MODIFICATION RECOMMENDED

N5222AS-01

N5222AS PNA Series Microwave Network Analyzers

Some analyzers are exhibiting unlocked or unleveled errors or other unexpected digital control faults. Analyzers that experience any of the symptoms listed on page 2 of this document must be inspected for a possible return to Agilent to have the system motherboard replaced.

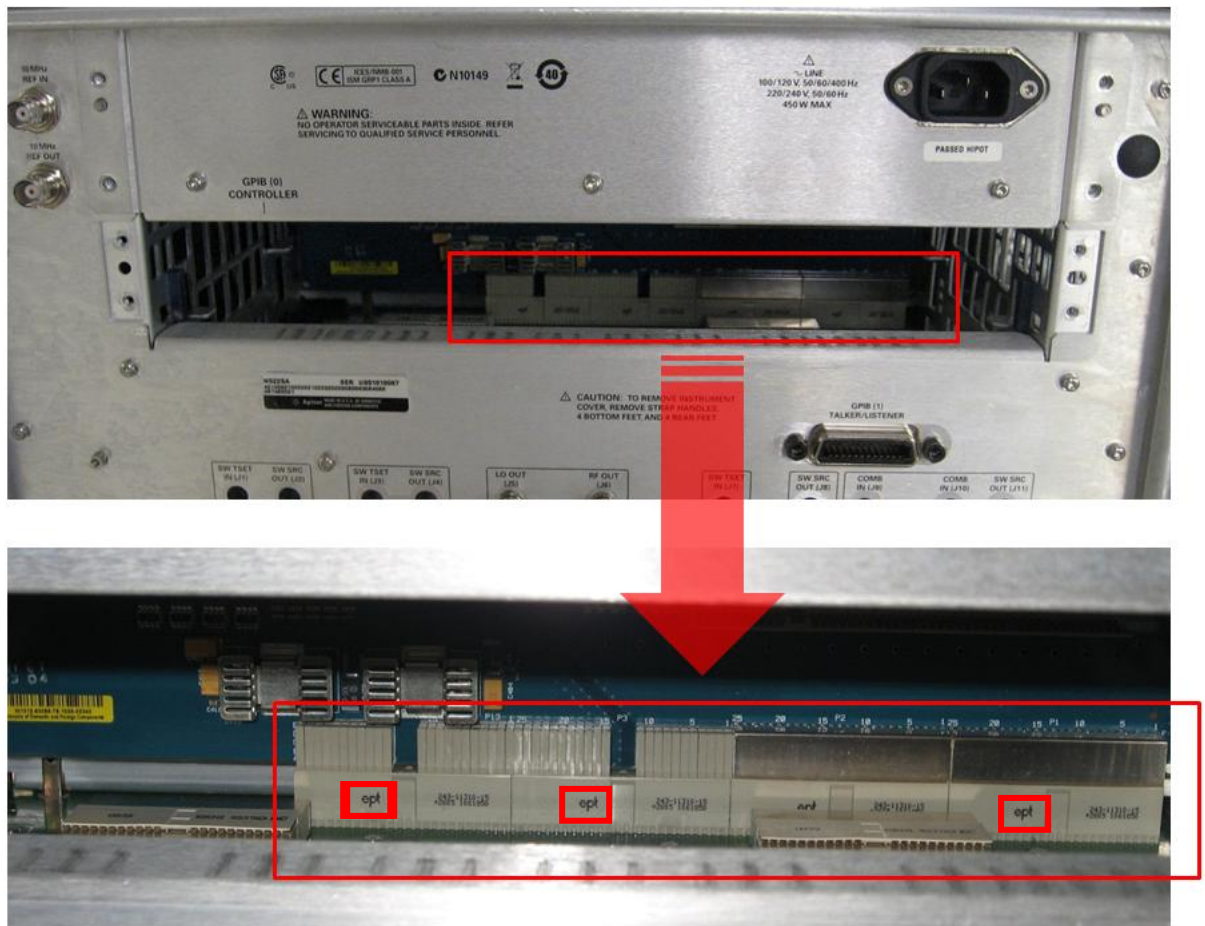
1. Remove the CPU assembly from the analyzer's rear panel. Refer to the PNA Service Guide chapter 7 section titled, "Removing and Replacing the CPU Board Assembly" for removal and reinstallation procedures. To view the online Service Guide, see the numbered list on the next page for instructions.
2. As per the photo below, inspect the system motherboard connector to see if it has one or more "ept" logos.

3. If the connector has one or more “ept” logos, return the analyzer to Agilent for replacement of the system motherboard. If the connector does not have one or more “ept” logos, email support_ctd-soco_support@agilent.com, providing the analyzer model and serial number and details of the malfunction symptoms.

4. *For Agilent Service Technicians only:* Only new boards without “ept” logos should be installed. Before installing the new board, look to see if it has one or more “ept” logos. If so, email support_ctd-soco_support@agilent.com, providing the analyzer model and serial number. Wait for further instructions in an email reply. New boards without “ept” logos can be installed.
For installation instructions, refer to the PNA Service Guide chapter 7 section titled, “Removing and Replacing the System Motherboard.” To view the online Service Guide, see the numbered list on the next page for instructions.
